**ADDENDUM #6**  
**ITB NUMBER: 2014043-CMO-B**  
**New City Hall ITB**

DATE: April 28, 2014

City of Harrisonburg's New City Hall ITB (2014043-CMO-B), is modified as follows:

**Item No. 6-9 Drawings, Sheet A1.1**

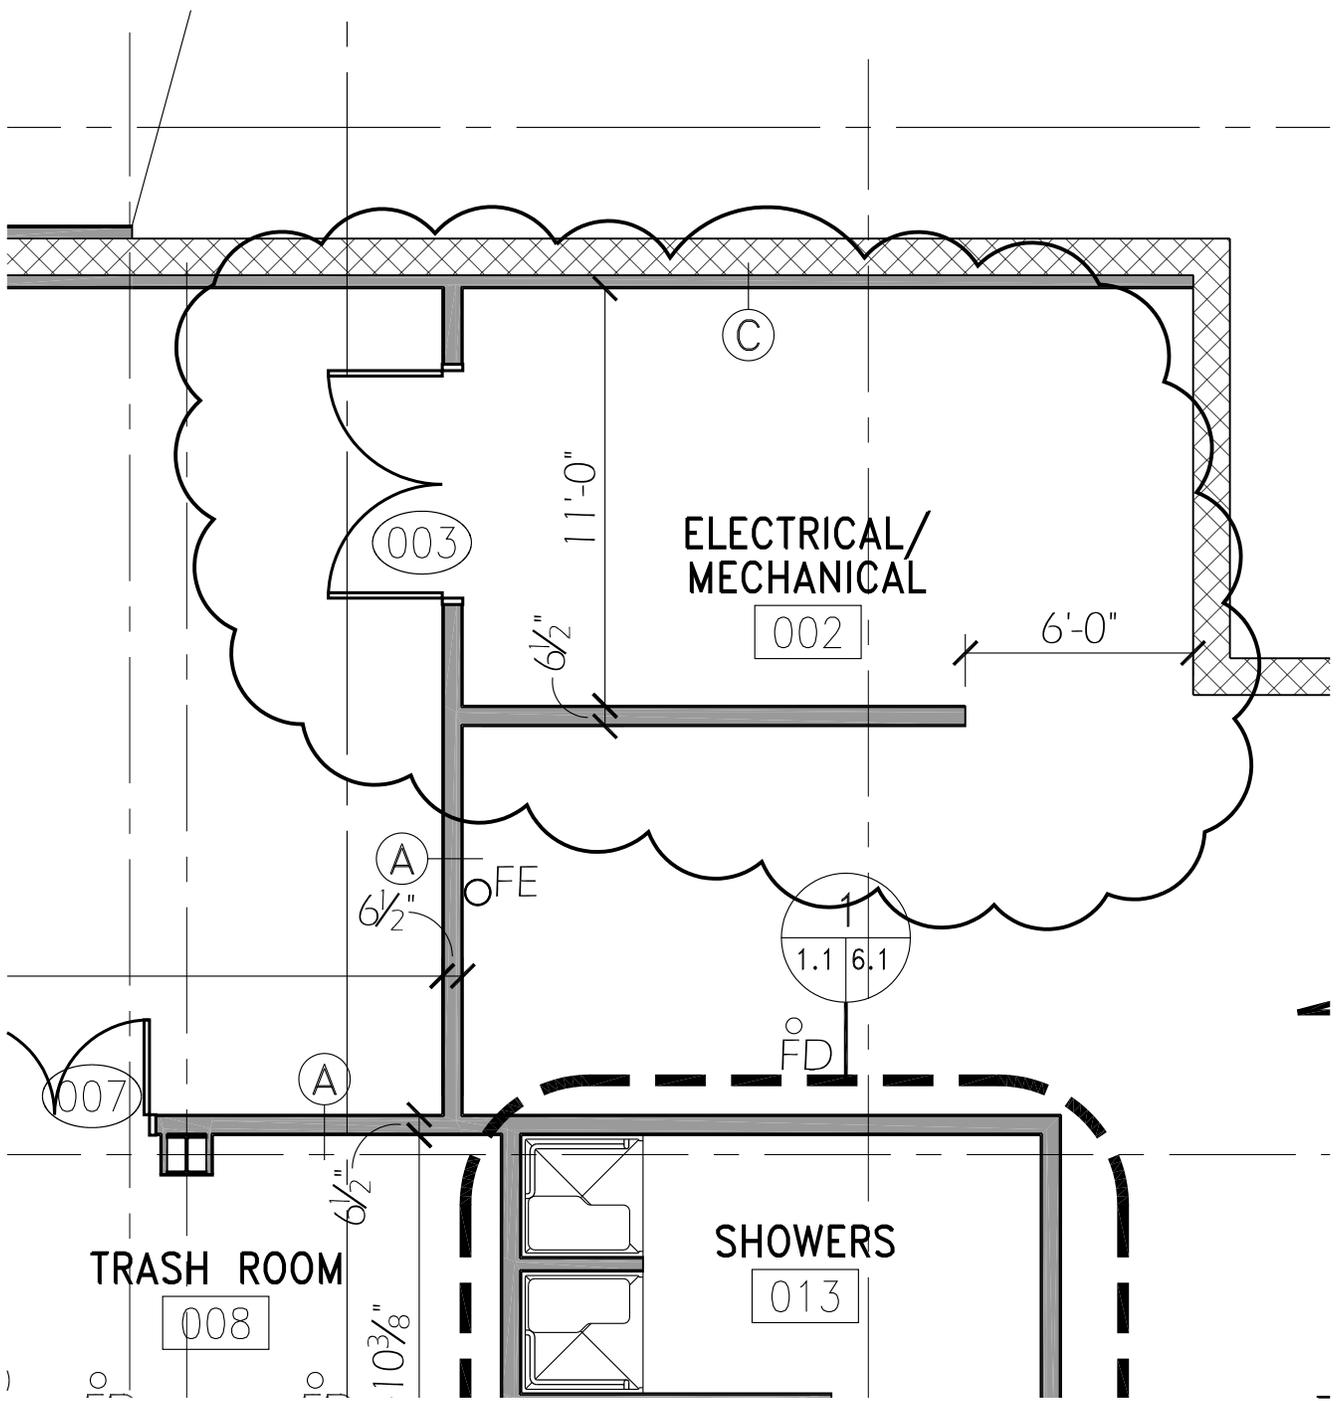
Supplemental Drawing A1.1b is issued herewith to show the addition of a wall in Mechanical Electrical Room 002
